Intel[®] Mobile Pentium[®] II Processor Specification Update

Release Date: March 2001

Order Number: 243887-030

Mobile Pentium® II Processor Mini-Cartridge Markings

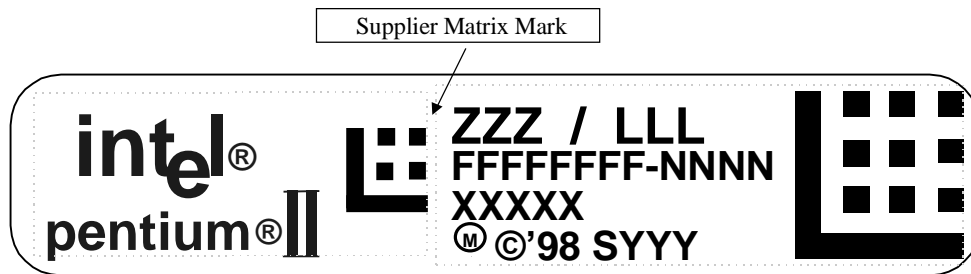
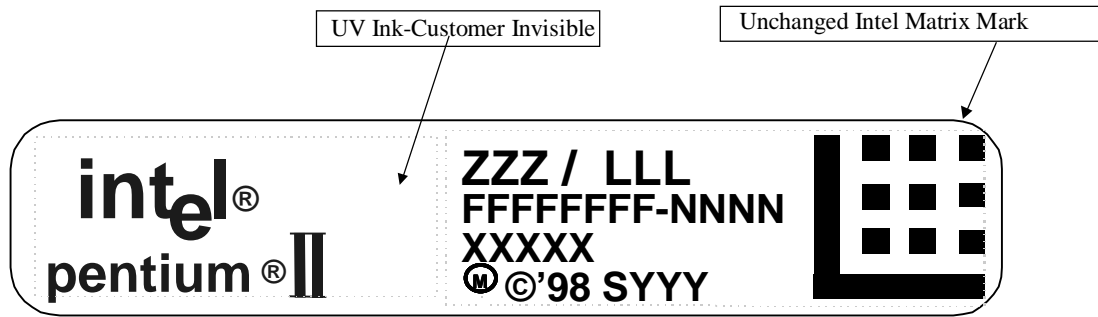
Old Mobile Pentium® II Processor in Mini-Cartridge Package Label with Supplier Matrix Mark

New Mobile Pentium® II Processor in Mini-Cartridge Package Label with Supplier Matrix Mark Removed

Figure 2. Workaround Flowchart: SMBALERT#-Driven System

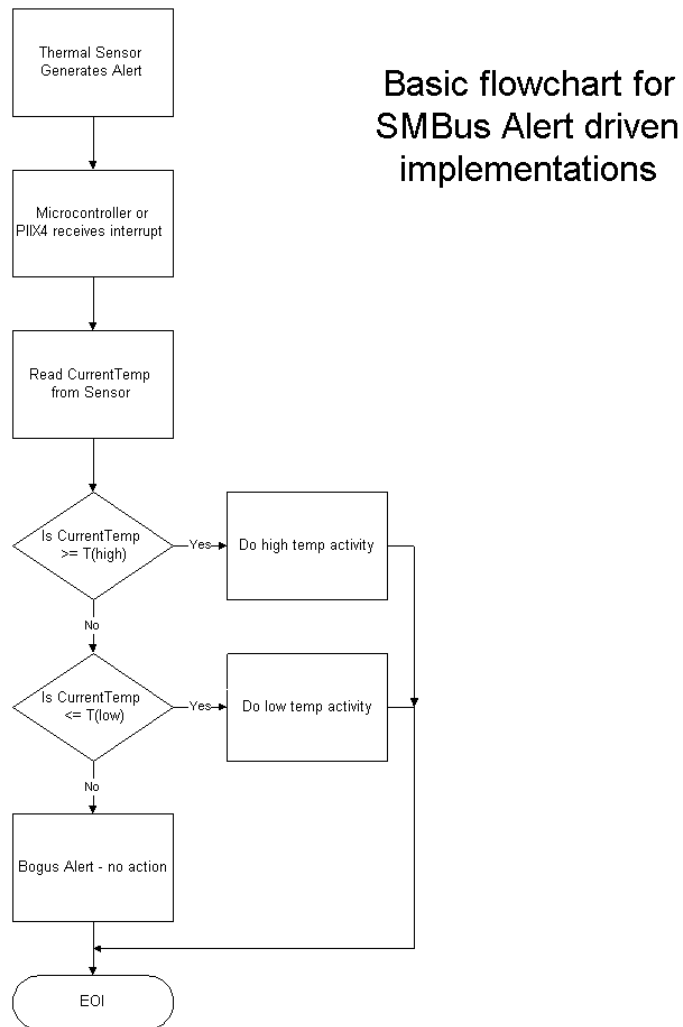
1. Before servicing an interrupt from the thermal sensor, read and compare the processor thermal reading with the threshold limits (T_{HIGH} or T_{LOW}). Figures 2 and 3 provide basic flowcharts for the implementation of this workaround in an interrupt driven system.
2. If the firmware implemented polls the Status Register only, then before taking any action, re-read the temperature register and do a comparison with the alarm threshold limits (T_{HIGH} or T_{LOW}) to determine if the value is actually still within the temperature window.

3. Use a temperature polling scheme to monitor the processor temperature.

Figure 5.6. Cross Sectional View with Vertical Dimensions

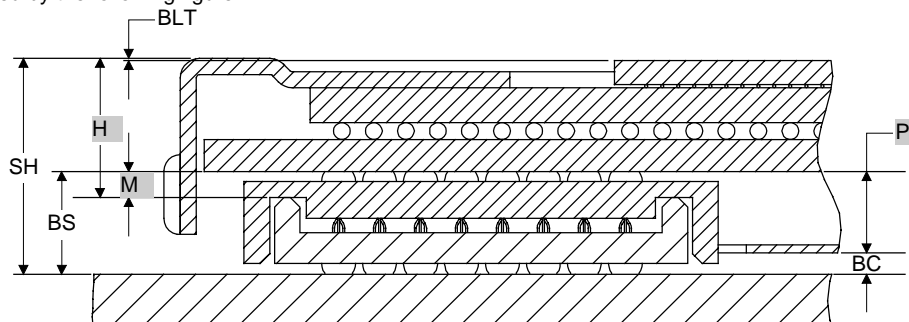
B1. Mislabeled Vertical Dimension Parameters

Figure 5.6 in the *Mobile Pentium® II Processor at 233 MHz, 266 MHz, and 300 MHz* datasheet should be replaced by the following figure:

Figure 5.3. Surface-Mount BGA1 Package—Top and Side View

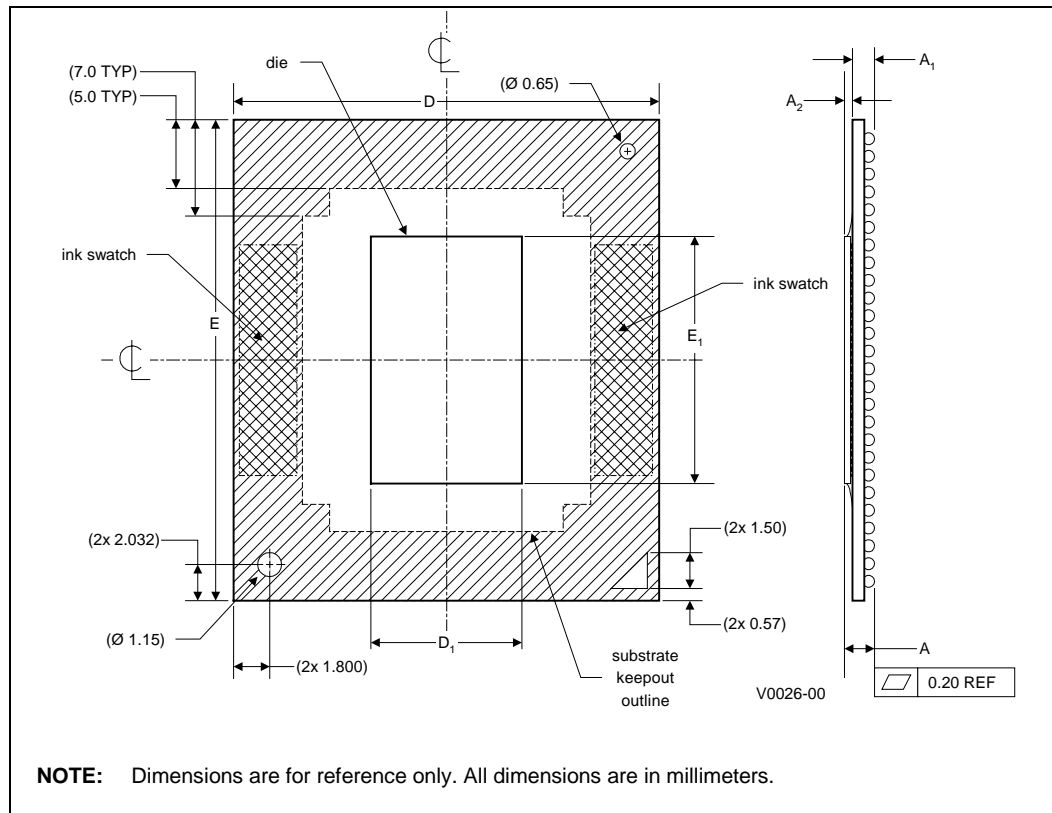
The following table and figures show the updated mechanical specifications for the BGA1 package, listed as Table 5.2, Figure 5.3 and Figure 5.4, respectively, in the *Mobile Pentium® II Processor in BGA Package at 366 MHz, 333 MHz, 300PE MHz, and 266PE MHz* datasheet.

Figure 3.3 Generic Clock Waveform

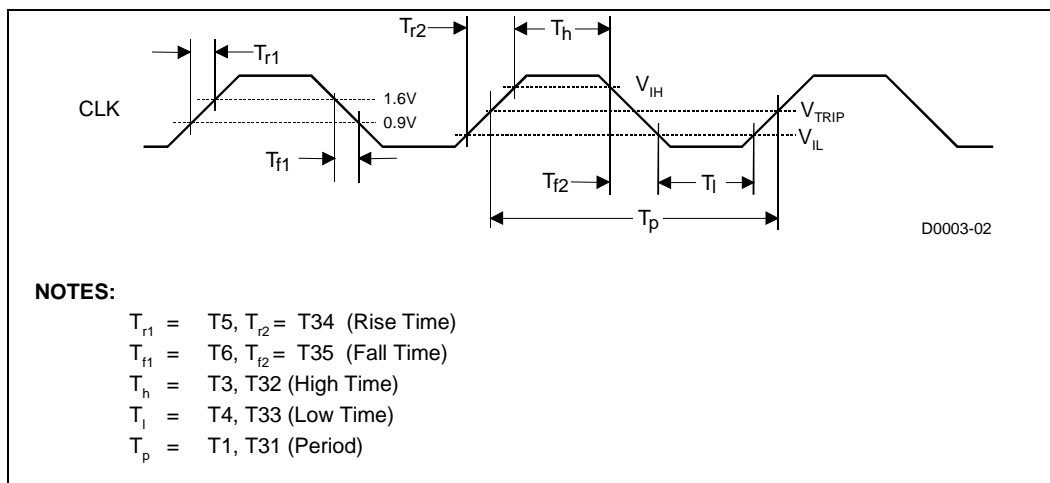
B14. Generic Clock Waveform Figure

Figure 3.3 in *Mobile Pentium® II Processor in Mini-Cartridge Package at 366 MHz, 333 MHz, 300PE MHz, and 266PE MHz* datasheet (Order Number 245108), and the *Mobile Pentium® II Processor in BGA Package at 366 MHz, 333 MHz, 300PE MHz, and 266PE MHz* datasheet (Order Number 245106) has been updated. The following figure is to replace the ones in the above documents.

Figure 1. TAP Gageable Thread Clarification

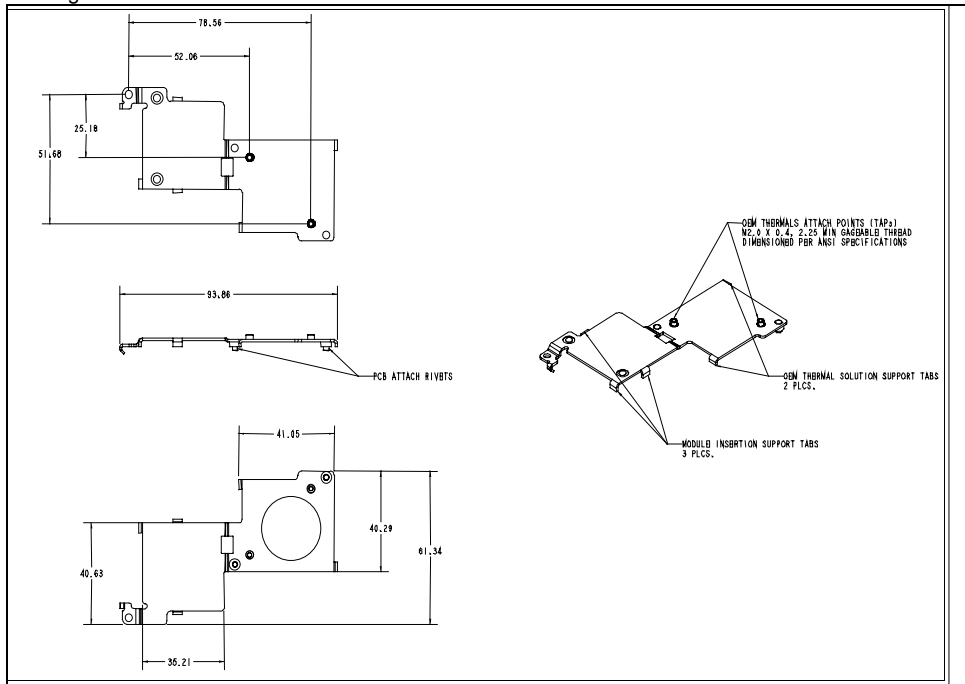
In the *Intel® Pentium® II Processor Mobile Module : Mobile Module Connector 1 (MMC-1)* and the *Intel® Pentium® II Processor Mobile Module : Mobile Module Connector 2 (MMC-2)* datasheets (Order Numbers 243667 and 243668, respectively), the thermal attach point (TAP) gageable thread specification was not clearly identified in Figure 14, of Section 5.2. The following is the TAP clarification:

OEM Thermal Attach Points (TAPs) M2.0 x 0.4, 2.25 min gageable thread dimensioned per ANSI specification.

See Figure 1 below for more information.
